SUBJECT: Criticality Safety Analysis License Amendment Request -
Responses to NRC Requests for Additional Information

Grand Gulf Nuclear Station, Unit 1
Docket No. 50-416
License No. NPF-29

**RESPONSES TO NRC REQUESTS FOR ADDITIONAL INFORMATION -
CRITICALITY SAFETY ANALYSIS LICENSE AMENDMENT REQUEST**

**RESPONSES TO NRC REQUESTS FOR ADDITIONAL INFORMATION -
GGNS CRITICALITY SAFETY ANALYSIS LICENSE AMENDMENT REQUEST**

Figure 3-1: Subsets of Database with 95/95 Fit

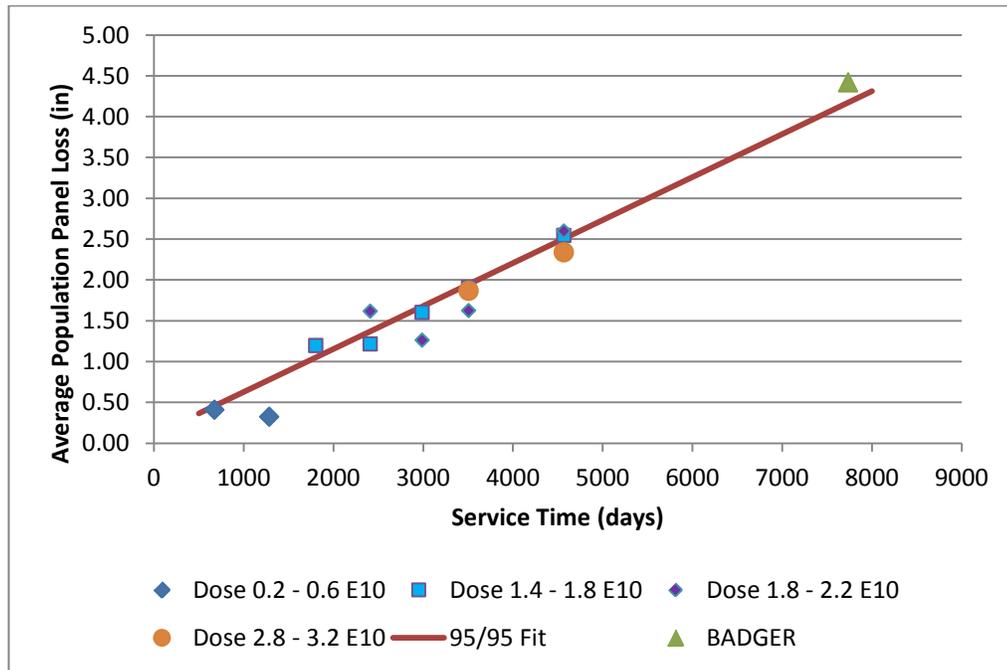
- 1) Please clarify if the issue of on-going Boraflex dissolution has been adequately incorporated. From the available literature, dissolution appears to have a significant effect on the edges of the panels, effectively reducing their width and length beyond the radiation damage-induced shrinkage. Boraflex dissolution does not appear to be limited to very high dose panels. The distributions used to describe the degraded Boraflex need to include consideration of the following:

Describe how these considerations are included in the development of the distributions used to simulate the degraded Boraflex. Where the issues have not or cannot be covered, please provide a quantified justification to support the acceptability not considering these issues.

The GGNS Boraflex gap measurements are summarized in Figure 1 provided in GNRO-2010/00073. That figure shows the evolution of Boraflex panel losses based on Blackness test measurements over the first 13 years of rack in-service life and the BADGER measurement that occurred after 21 years of in-service life. Figure 1 presents the measurement database as a function of panel dose that has been shown to be related to panel shrinkage. For racks with an in-service life like GGNS, dissolution effects are dominantly impacted by the time a given panel has exceeded a relatively small dose. The GGNS measurement database reflects both shrinkage and dissolution effects. In order to separate the effects, sub-sets of the database were selected with a similar dose (i.e., narrow range of dose values). Since these panels achieved the target dose over different time periods, the panel loss attributable to dissolution effects over time can be evaluated. For this evaluation, the time since the initial irradiation is used (i.e., the end of Cycle 1 in 1986). Four separate sub-sets of the database were compiled, with different target dose values. The dose targets cover a wide range of dose values, with some extending above the Region I dose limit. The evaluation of this data is illustrated in Figure 3-1, below, which shows a strong relationship of panel loss with time that is not dependent on dose.

A regression fit of the data resulted in an R-squared value of 0.906. The BADGER test data was not included in the development of the correlation since there are too few measurements with a common dose or irradiation history. However, subsets of low dose, long in-service life panels from the BADGER measurements demonstrate the correlation's applicability. The 95/95 upper limit of the fit is used to evaluate the dissolution effects on gap growth for the GGNS racks.

Figure 3-5: Axial Probability Distribution of Dissolution Features

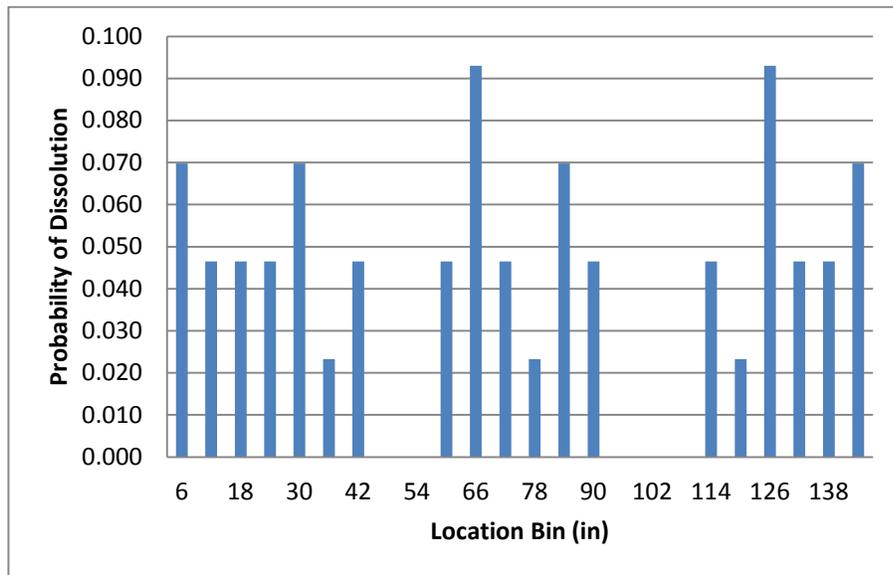
- *Effects of scallop formation and any other forms of localized thinning*
- *Future panel dissolution*
- *Local (i.e., from panel to panel) dissolution rate variation that would occur due to manufacturing and environmental variations*
- *Local dissolution rate variation due to manufacturing defects and fuel storage rack damage*

In addition to the gap growth due to dissolution discussed above, the reactivity effects of areas of local dissolution have been evaluated based on analysis of the BADGER test data. Detailed maps of the BADGER measurements for the Region I and Region II panels were analyzed to determine the location and geometry of areas where local dissolution is present. The evaluation considered dissolution features (e.g., scallops) associated with Boraflex gaps separately from dissolution features that are not associated with gaps. Features associated with gaps have the same location distribution as gaps. Features not associated with gaps are observed to be uniformly distributed axially, as shown in Figure 3-5, below.

For both sets of dissolution features, the dimensions of each feature were determined and a 95/95 upper limit was calculated, as summarized in Table 3-1, below.
